GRCA Agency Review Document Book

GRCA Agency Review Document Book Index

**RE: Application for Zoning By-Law Amendment
8352 Highway 7
Part lot 1, Concession 6, Township of Guelph/Eramosa
634745 Ontario Limited / James Dick Construction Limited**

**Re: Response to GRCA comments regarding Hidden Quarry
Guelph-Eramosa File ZBA09/2012
Cumulative Effects Assessment Issues**

Figure 1: Aggregate Sites

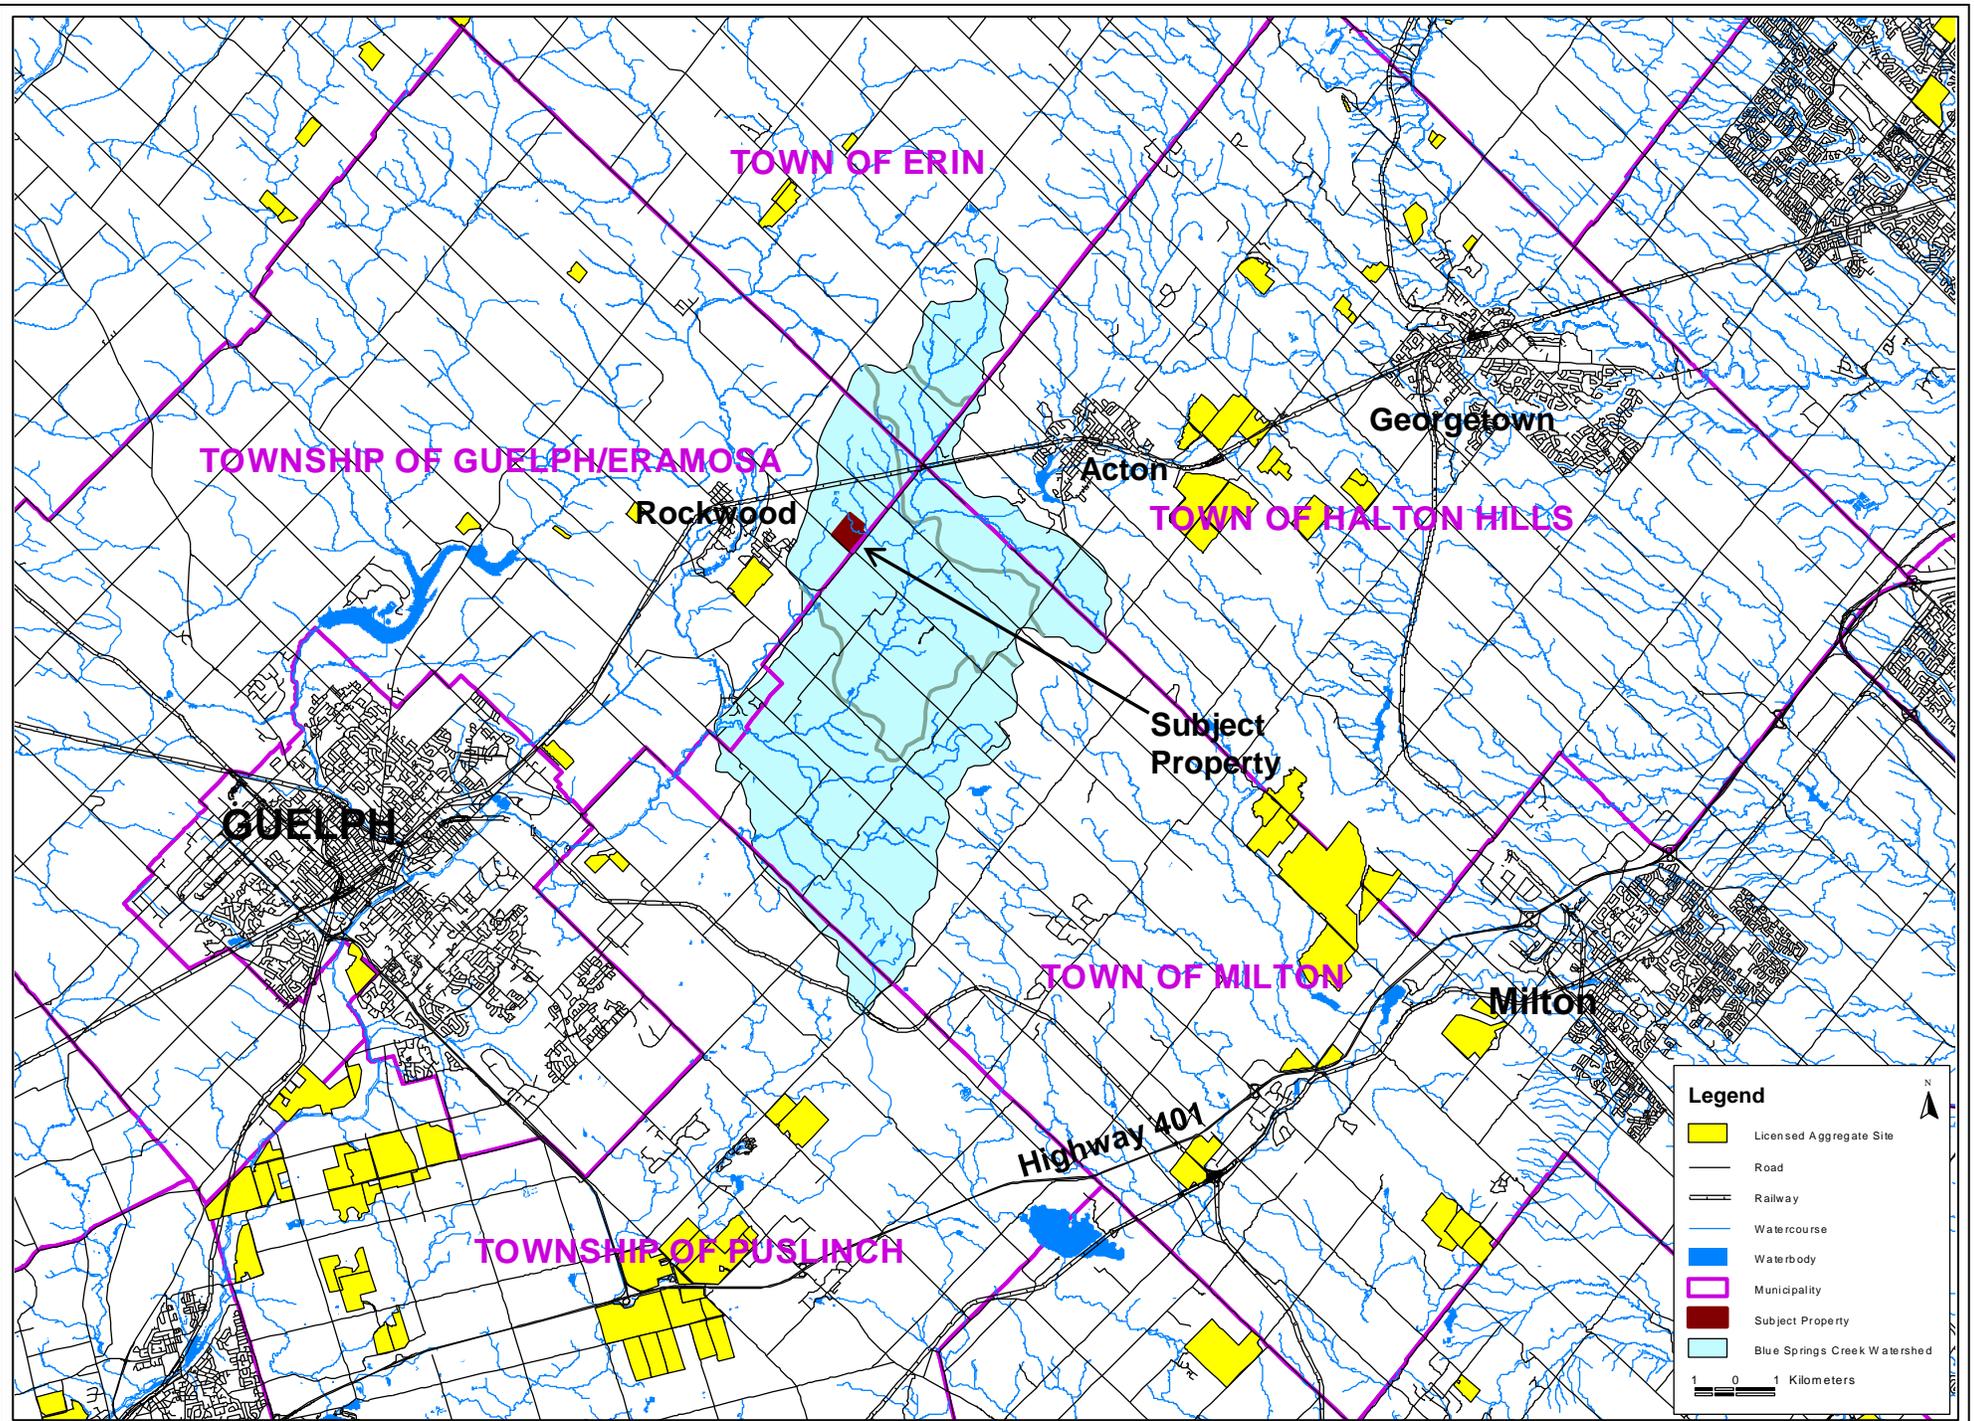
The proposed Hidden Quarry is several kilometers from the nearest licenced pit or quarry and there are no other licensed pits or quarries in the Blue Springs Creek subwatershed (Figure 1). There is no potential for the overlapping of areas of influence between the proposed Hidden Quarry and the nearest licenced pit or quarry.

Figure 1 clearly shows that there are no other extractive operations within the Blue Springs Creek subwatershed and therefore, cumulative effects need not be considered at this time.

**Figure H8:
Calibration Statistics**

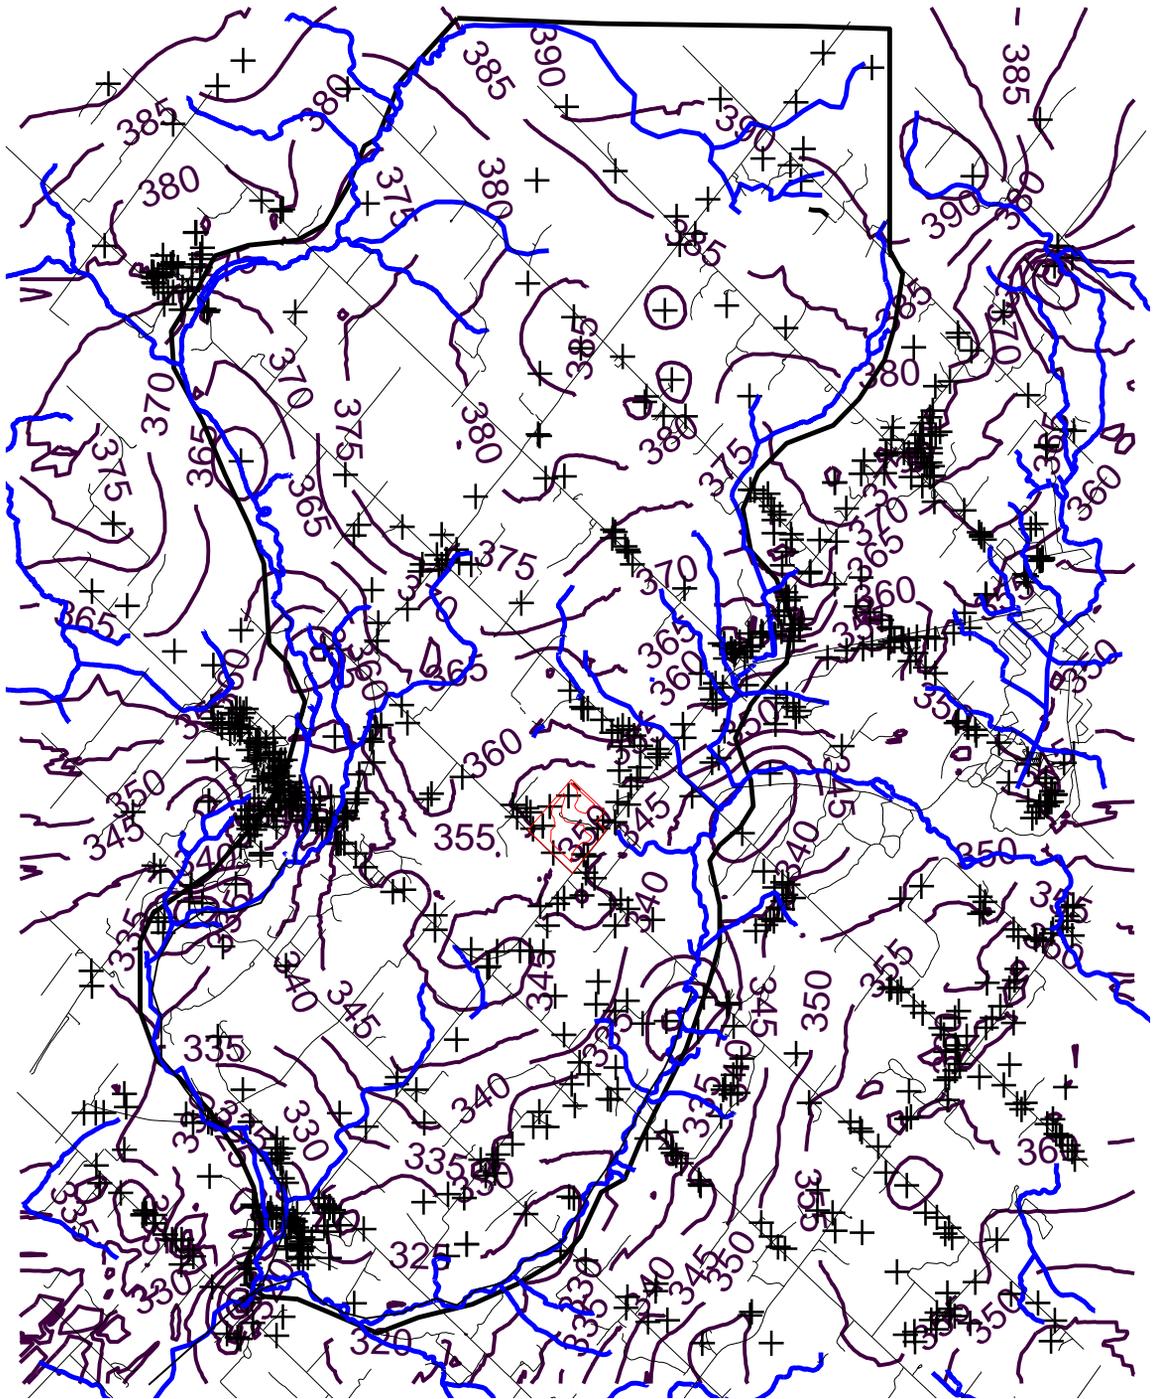
Burnside Hydrogeological Comments	48	- Figure H10 provides the predicted groundwater flow in the bedrock. How does this compare to the current flow direction?	The calibration of hydraulic potentials is provided in our report on Figure H8, confirming a good correlation to observed water levels. The static water levels available from the water well data base were kriged and the result is shown on the attached Figure R6 for an area near to the site and on Figure R7 in a regional perspective. A similar pattern of groundwater flow occurs in the model simulation.	No Action Required

Figure 1: Tributary B Flood Level

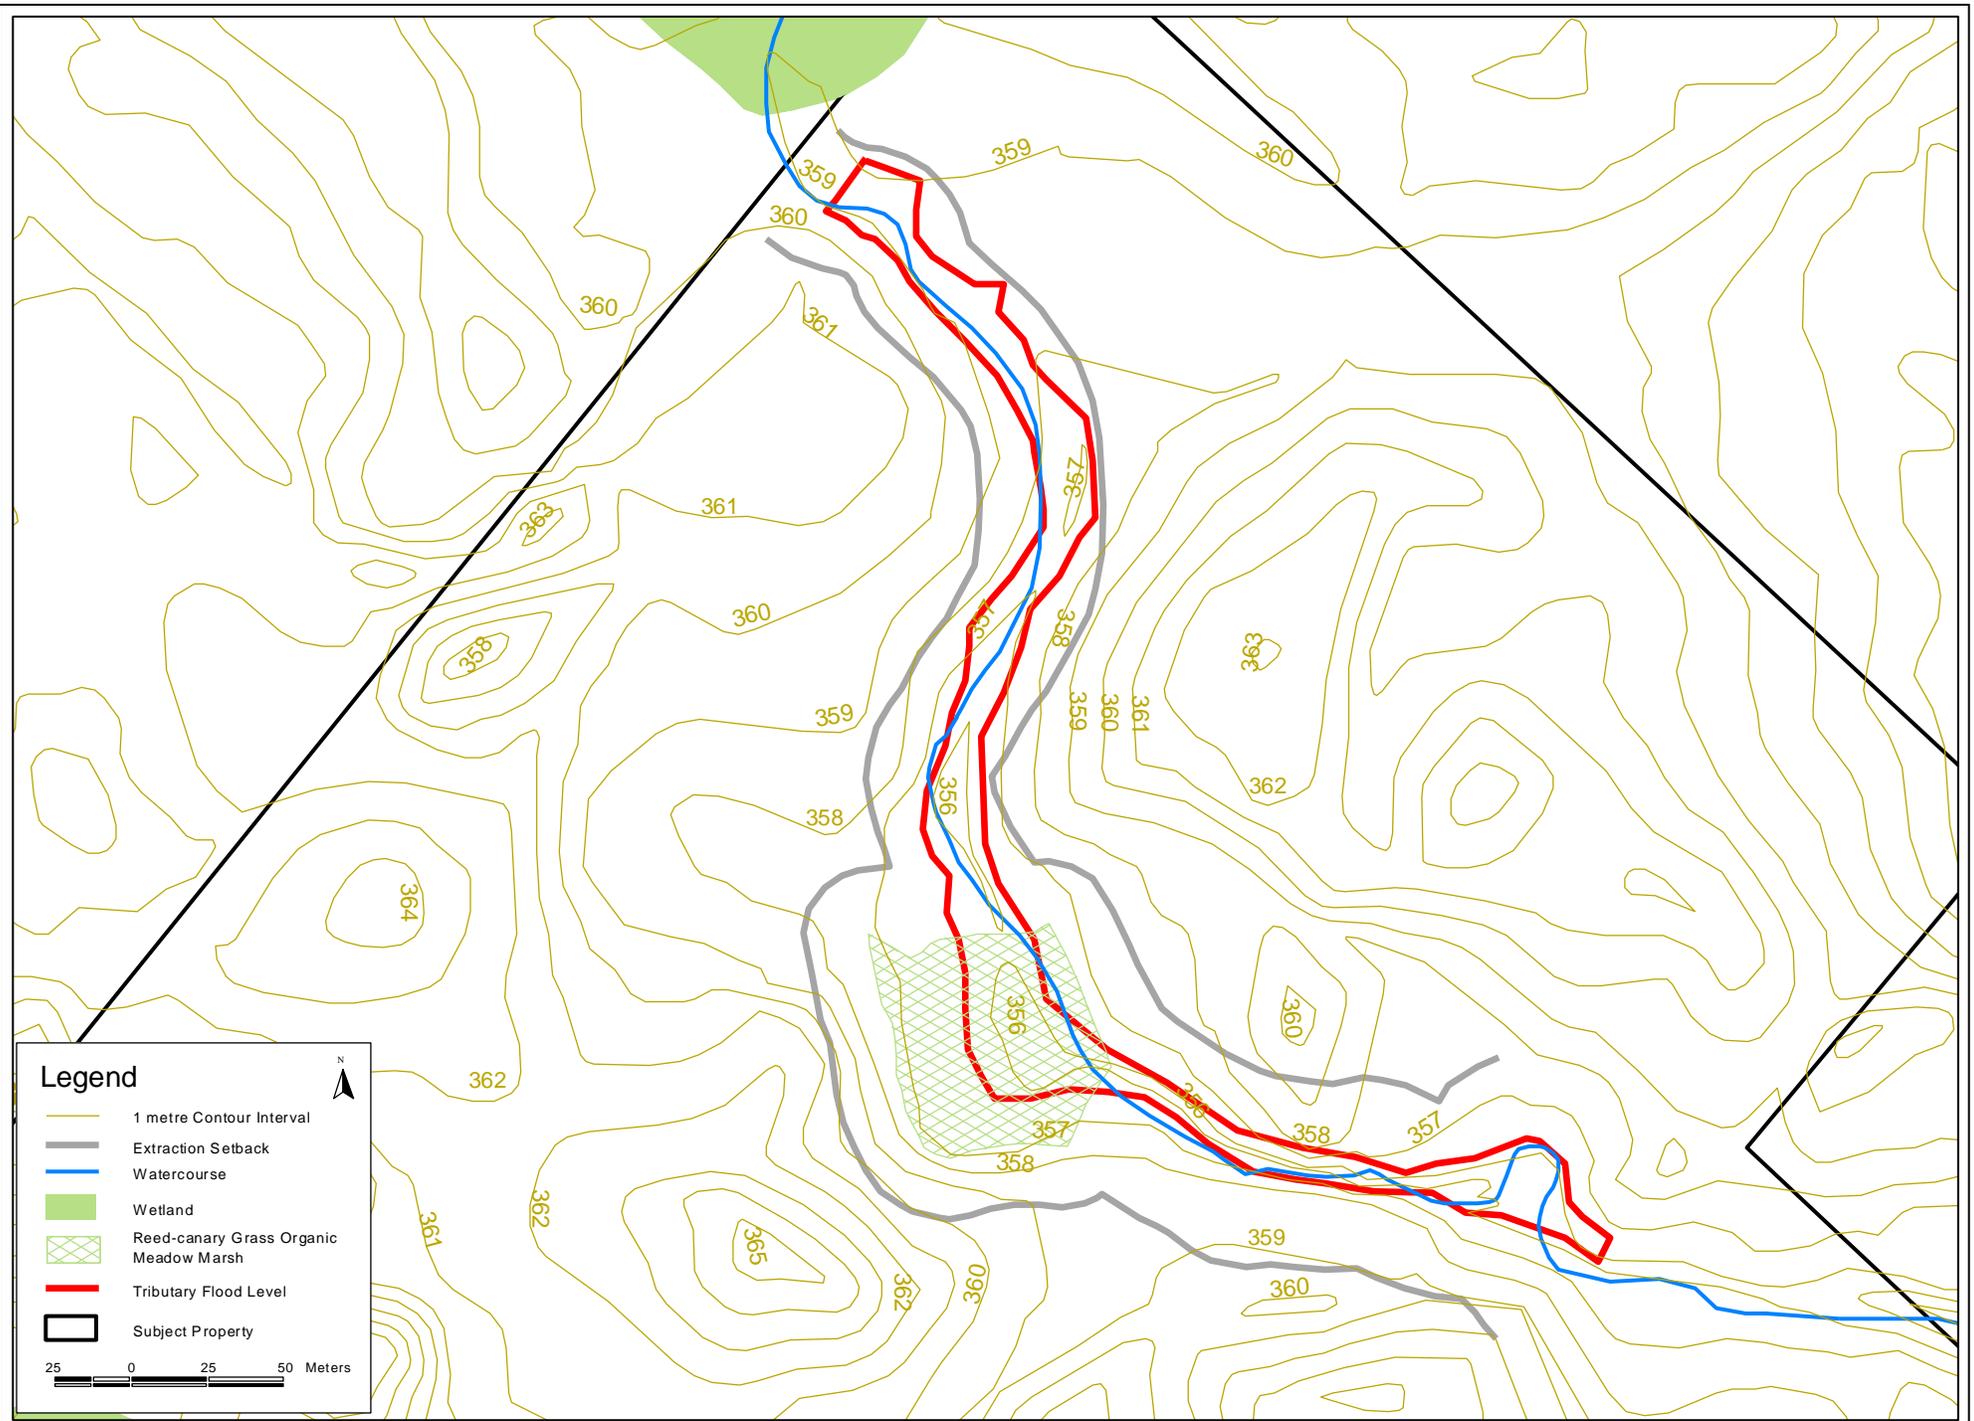
Comparing flood levels in Tributary B to ground elevations results in the flooding of areas shown on Figure 1. It can be seen that when at historical flood levels, Tributary B will remain confined within the proposed buffer. This analysis was done by comparing kriged ground elevation data and kriged surface water level data within the Viewlog™ geospatial data analytical software package.

Figure 1: Marsh Catchment Area Reduction Zone

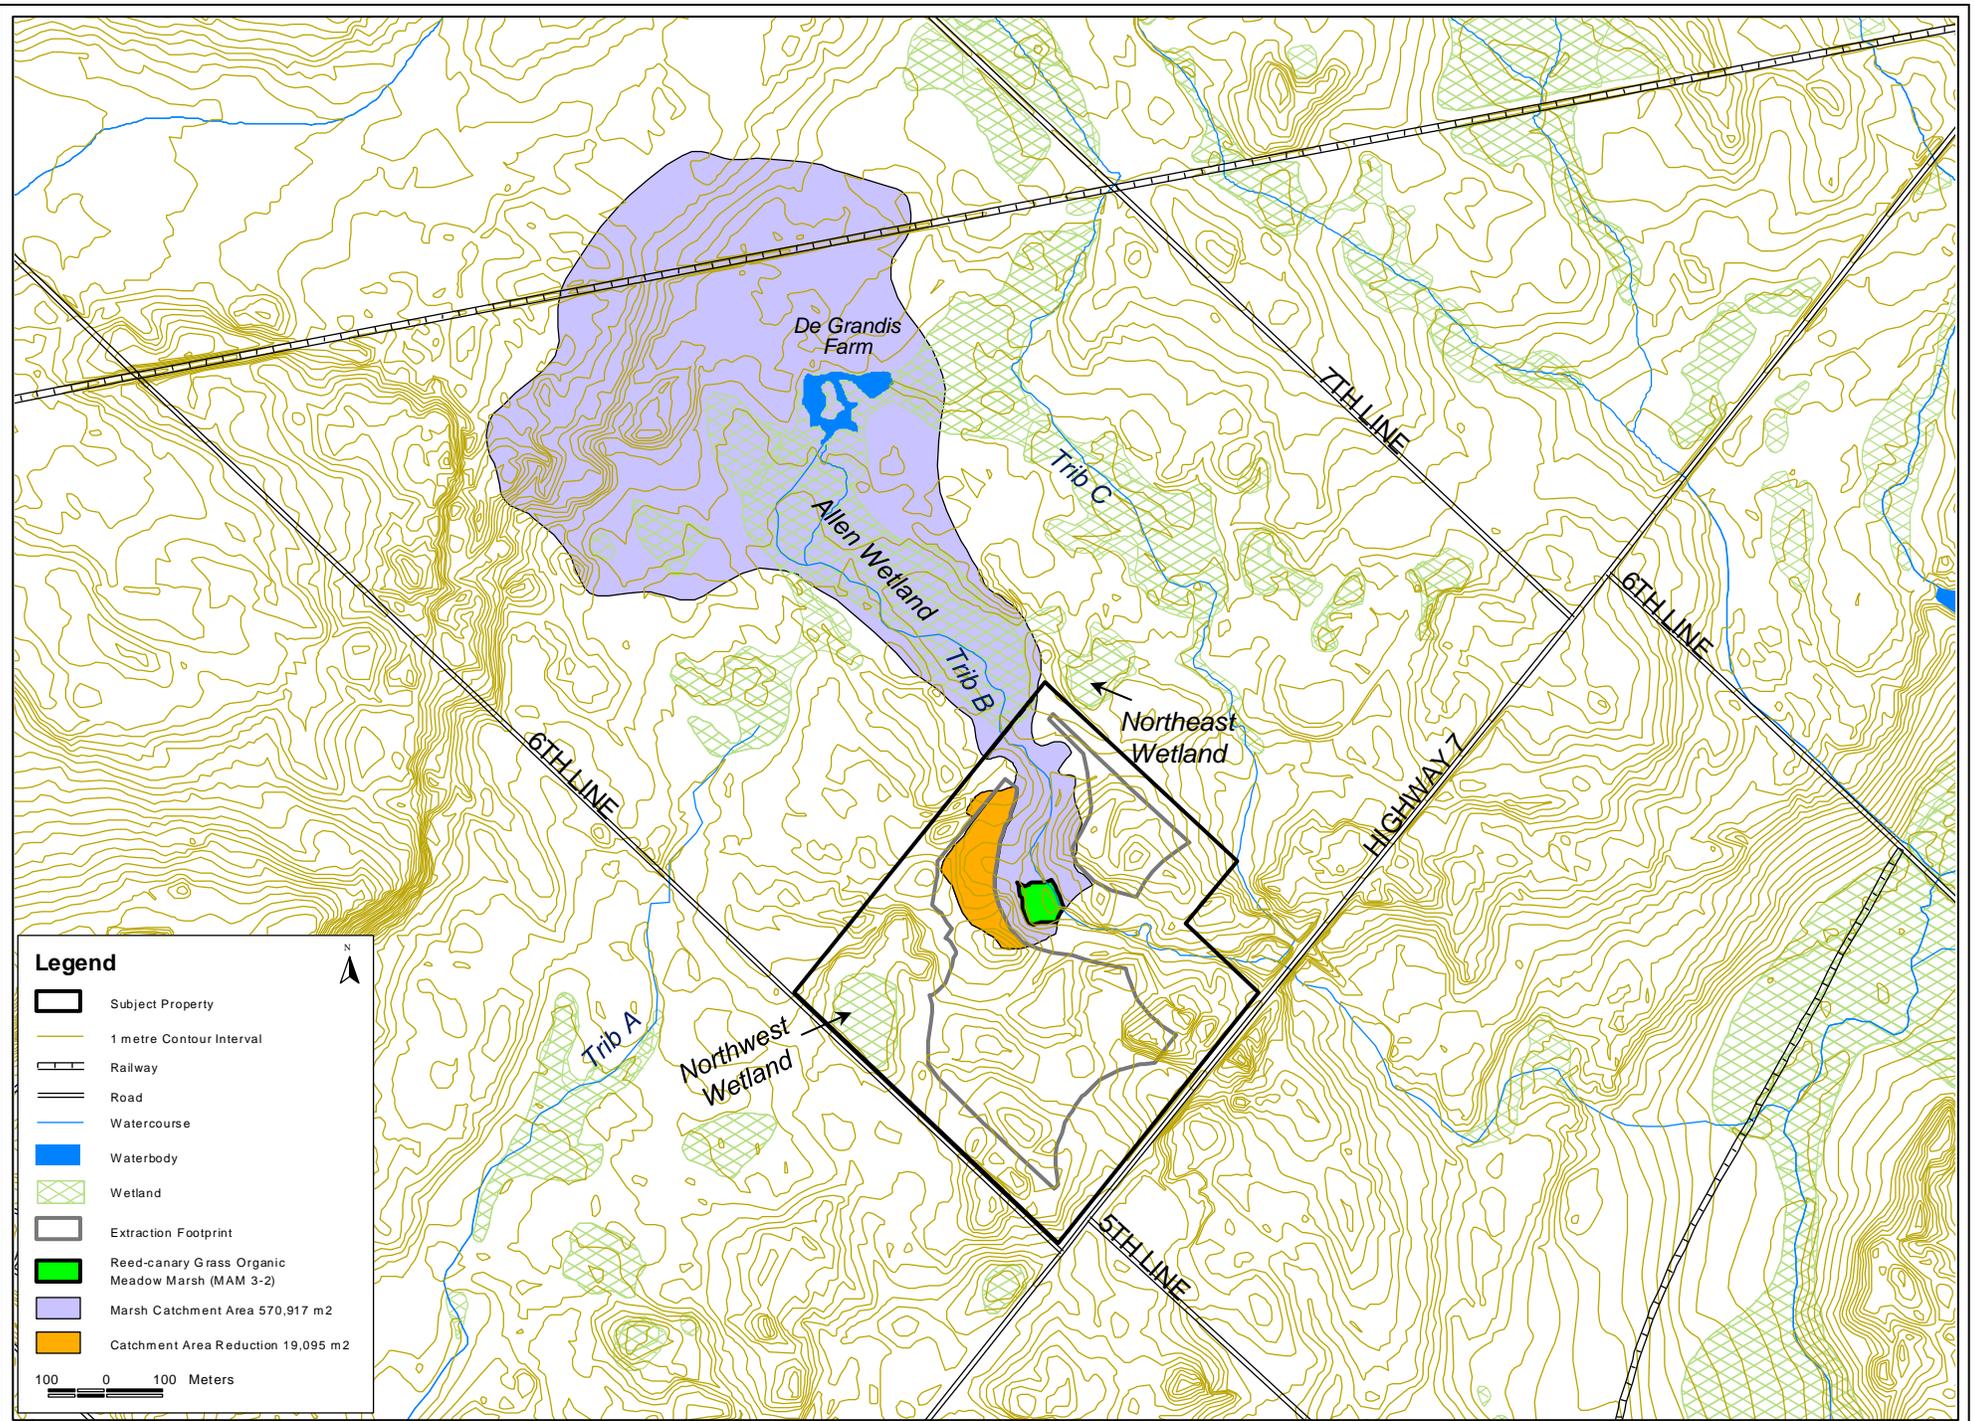
The present day surface water catchment area of the riparian wetland is shown on Figure 1. The catchment area is 570,917 m². The potential reduction in surface water catchment area from the proposed quarry is 19,095 m². The reduction in area represents 3.3% of the total catchment area of the riparian wetland. It is our opinion that this reduction is insignificant relative to the remaining contributing area. In addition, annual variability in precipitation rate is much greater than 3.3% and therefore the wetland is already accustomed to significant variability in support hydrology. Also, we have been on the site over one hundred and fifty times since 1995 and other than possibly in the spring, we have not observed overland flow from the upland forest into the wetland. This is due to the relatively low slope, heavy tree cover and relatively high permeability of surficial soils.
